As-built Baseline Monitoring Report FINAL

UT to Rush Fork Stream Mitigation Project

DMS Project ID No. 100068

Subject: Response to DMS Comments (June 24, 2022) for Draft As-Built Baseline Monitoring Report. UT to Rush Fork Stream Mitigation Project, Haywood County
French Broad River Basin: 06010106
DMS Project #100068

BAKER PROJECT REFERENCE NO. 166680	SHEET NO. 5
PROJECT ENGINEER	
APPROVED BY:	
DATE:	
Michael Baker International	
Michael Baker Engineering Inc. 5030 Regency Parkway, Suite 500 Cary, NORTH CAROLINA 27518 Phone: 919.453.5488 Fax: 919.453.5490 License #: F-1084	
NCDMS ID NO. 100068

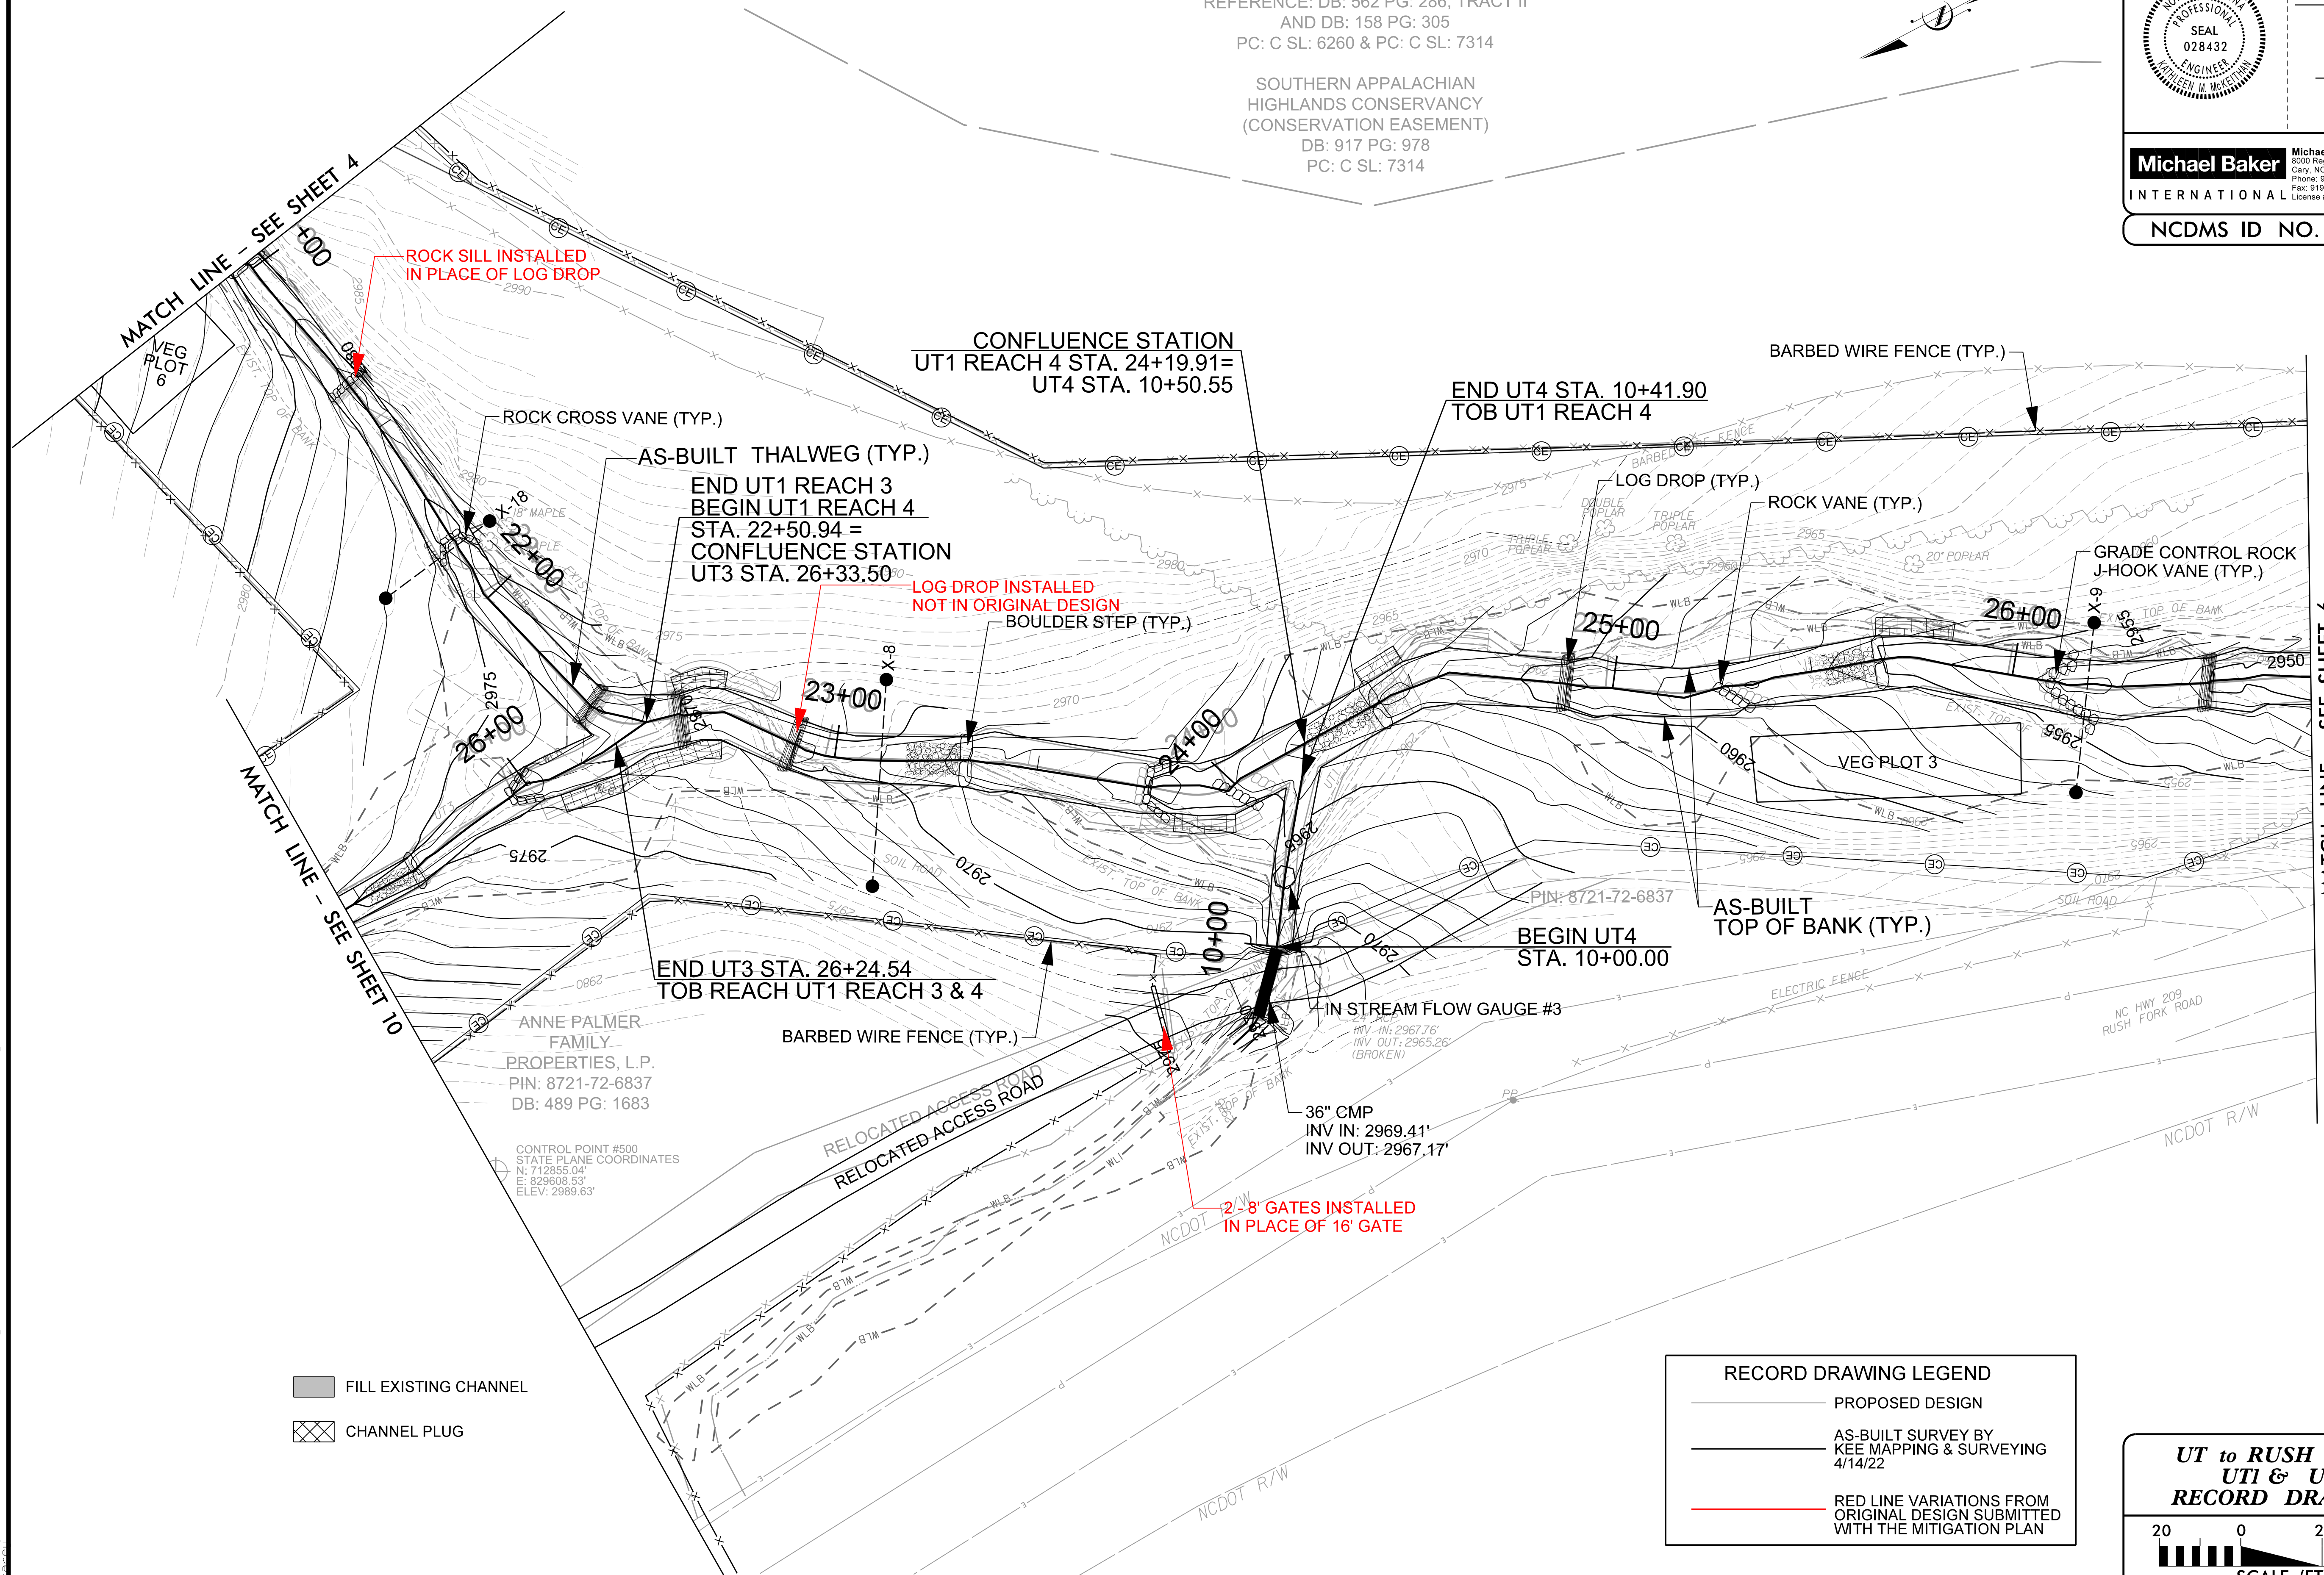
- Appendix E - Record Drawing Sheet 5: Sheet 5 shows a portion of the crossing infrastructure (pipe and headwall) installed inside the conservation easement. This infrastructure encroachment was confirmed in the field by DMS and Baker on 6/14/2022. The crossing infrastructure should be moved outside of the recorded conservation easement, or a conservation easement modification will be required. Any conservation easement modification costs will be the responsibility of the full delivery provider (Baker). Please discuss a proposed resolution in the comment responses. The proposed resolution will need to be reviewed and approved by the IRT as part of the MY0/ As-built IRT review prior to implementation.

RESPONSE: Baker has worked with the contractor to move the crossing infrastructure just upstream of the CE line. This modification was completed on July 25, 2022.

**UT to RUSH FORK
 UTI
 RECORD DRAWING**

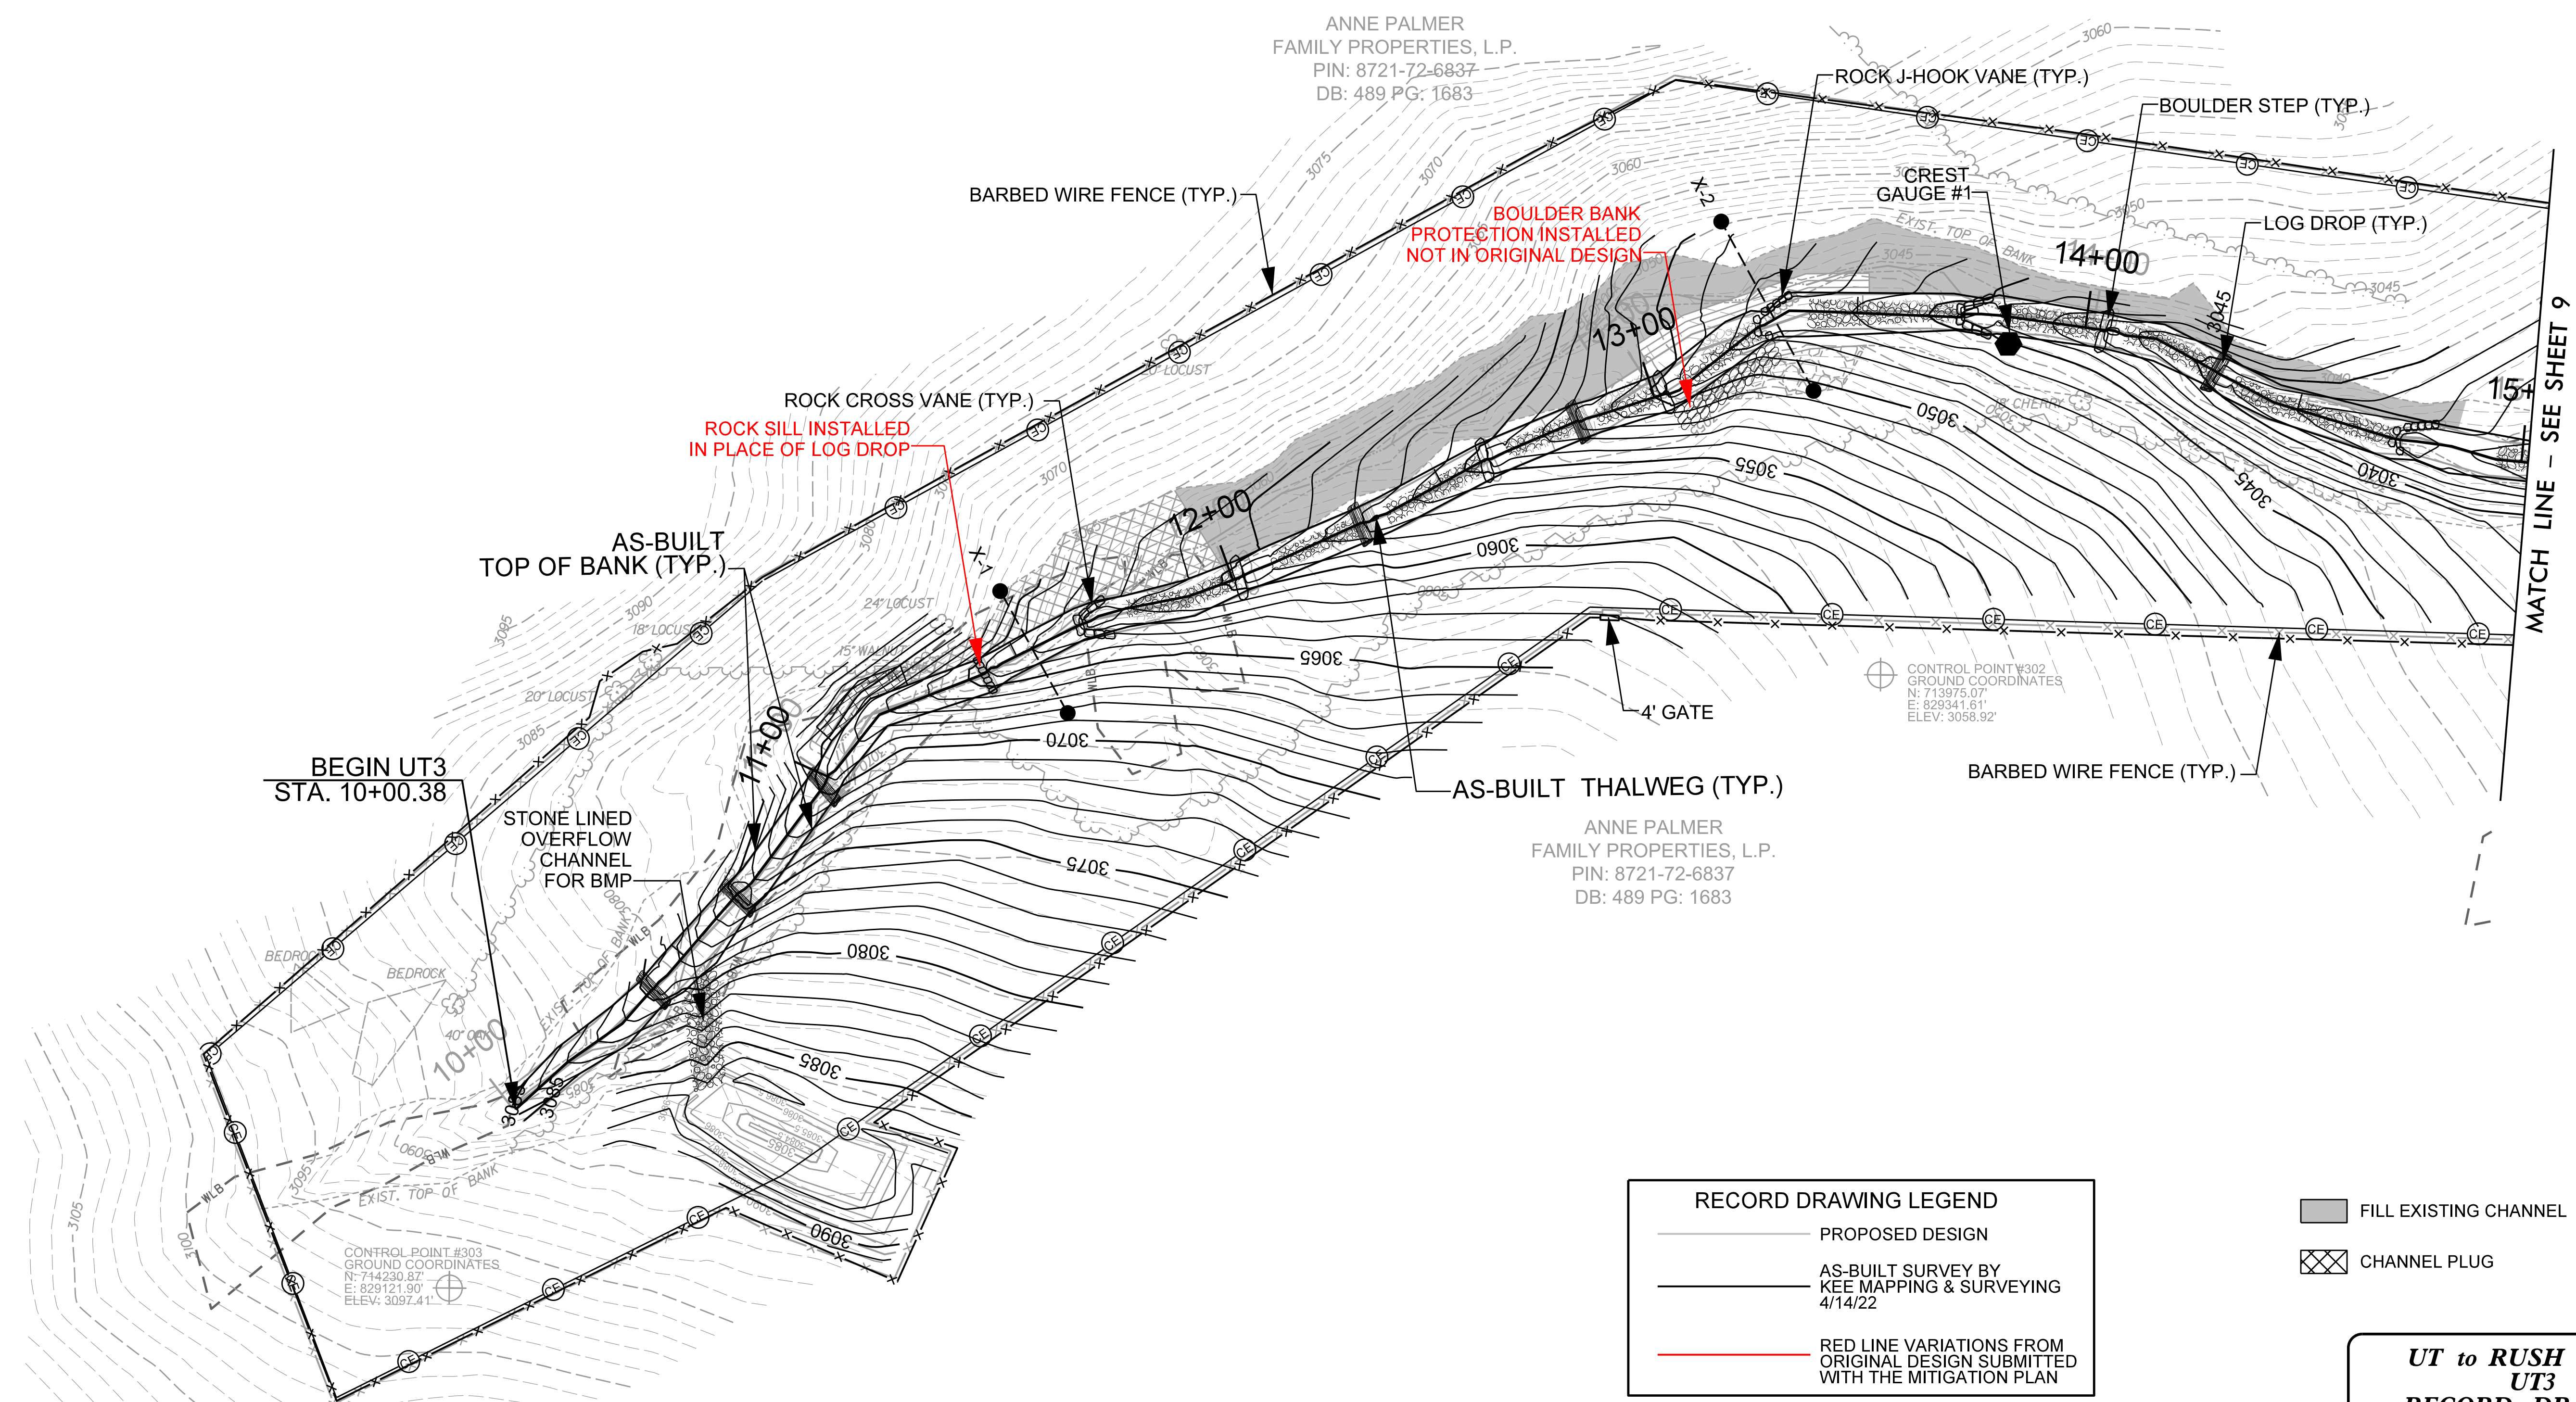
- Appendix E - Record Drawing Sheet 7: Please confirm that the pre-existing soil road shown within the conservation easement has been either moved or extinguished as part of the project construction. In the revised record drawings, the sheet should be updated to show the soil road relocation area or a call out should be provided noting that the soil road was extinguished as part of project construction and implementation.

RESPONSE: We acknowledge the soil road is shown on Sheet 7; however, this is only intended to describe a topographical and historic feature on the landscape. The road has long been abandoned for any use and is currently vegetated with mature trees and lacks any connection to any usable roadways. Moreover, there is no existing Right of Way, and the old roadbed was not used during construction of this project.

5/24/2022
 M:\Projects\166680_Rush_Fork\Design\As-Built\Plans\166680-ASB-FSH-08.dgn
 Michael Baker Engineering Inc.

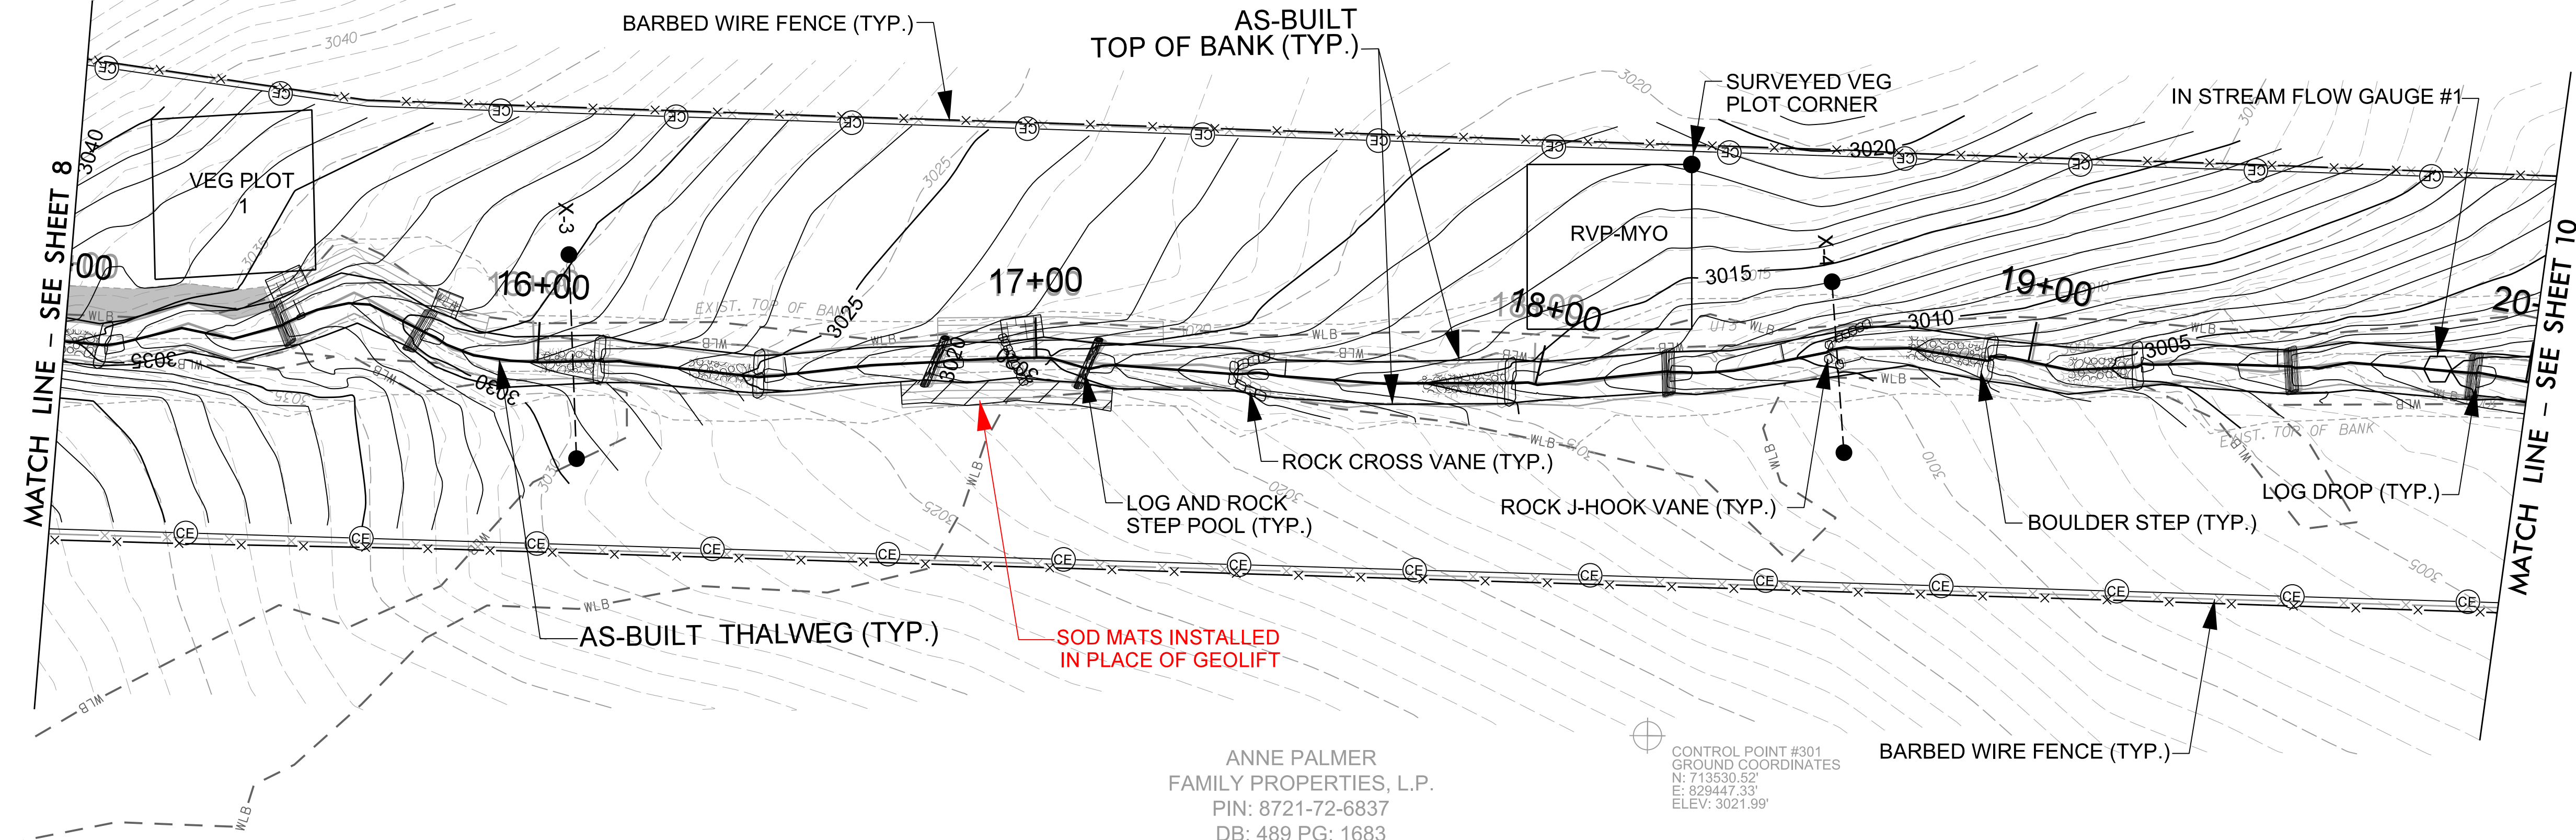
- Appendix E - Record Drawing Sheet 8: Sheet 8 shows a portion of the project BMP located within the conservation easement and a portion of the BMP located outside of the conservation easement. Please explain why the BMP is partially located in the conservation easement and indicate if BMP maintenance will be required in the monitoring term or in long term Stewardship. If a conservation easement modification is required based on the comment above and IRT review, DMS and DEQ Stewardship highly recommend including the entire BMP and associated infrastructure inside the modified conservation easement. Please discuss a proposed resolution. As noted above, this should be reviewed and approved by the IRT as part of the MY0/ As-built IRT review prior to implementation.

RESPONSE: The capacity of the designed BMP needed to increase to function as intended. This design was implemented after the establishment of the conservation easement,

resulting in a portion of the BMP being located outside the conservation easement boundary. It should be noted that livestock fencing surrounds the entire BMP with permission and cooperation from the landowner. This arrangement was shown in the approved Mitigation Plan on Sheet 9 of the included project plans, thus review and approvals have already taken place. Functionality of the BMP will be assessed in future monitoring years to determine if maintenance will be required; although no maintenance outside the conservation easement boundary is anticipated.
